Access Compliance Report Public Rights-of-Way (Curb Ramps)

Main Street: ST_JOHN_PL Cross Street: BIMINI_DR Location: NE

ADA ID: RPRK211013143555 Ramp Type: Type 1 - Perpendicular Diagonal Initial Pass/Fail: Fail Overall Compliance: No Severity Score: 2

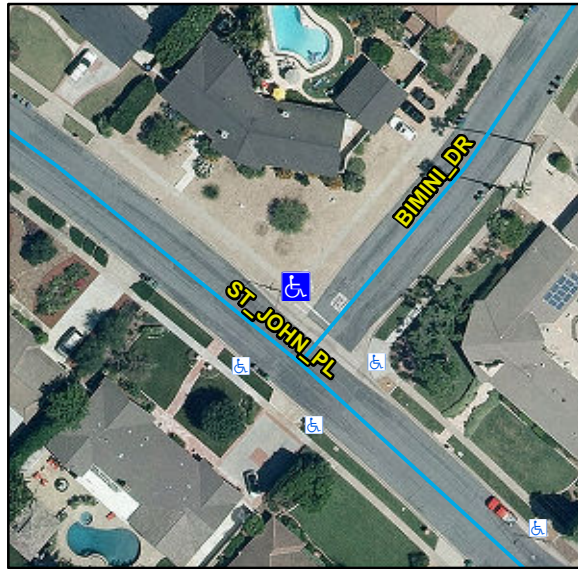
Compliance	Description	Data	Compliance	Description	Data
N/A	Ramp Length (in)	128	N/A	Flare Type LT	
Yes	Ramp Width (in)	48			N/A
Yes	Ramp Run Slope (%)	4.7	N/A	Flare Slope LT (%)	N/A
No	Ramp Cross Slope (%)	3.4	N/A	Flare Traversable LT	N/A
N/A	Landing Present	N/A	N/A	Flare Type RT	
N/A	Landing Length (in)	N/A			N/A
N/A	Landing Width (in)	N/A	N/A	Flare Slope RT (%)	N/A
N/A	Landing Run Slope (%)	N/A	N/A	Flare Traversable RT	N/A
N/A	Landing Cross Slope (%)	N/A	N/A	DWS Provided	N/A
N/A	Landing Movement Obstructed?	N/A	N/A	DWS Contrast	N/A
	Landing Movement Type	N/A	N/A	DWS Length (in)	N/A
N/A	Landing Shared	N/A	N/A	DWS Full Width	N/A
N/A	Clear Space	Yes	N/A	DWS Offset Left (in)	N/A
N/A	Clear Space To Crosswalk (in)	N/A	N/A	DWS Offset Right (in)	N/A
N/A	Marked Crosswalk 1	No	N/A	Marked Crosswalk 2	No
	Crossing 1 Direction	SW		Crossing 2 Direction	SE
	Marked Crosswalk 1 Width (in)	N/A		Marked Crosswalk 2 Width (in)	N/A

Remove & Replace Curb Ramp With Two New Directional Ramps or Equivalent.
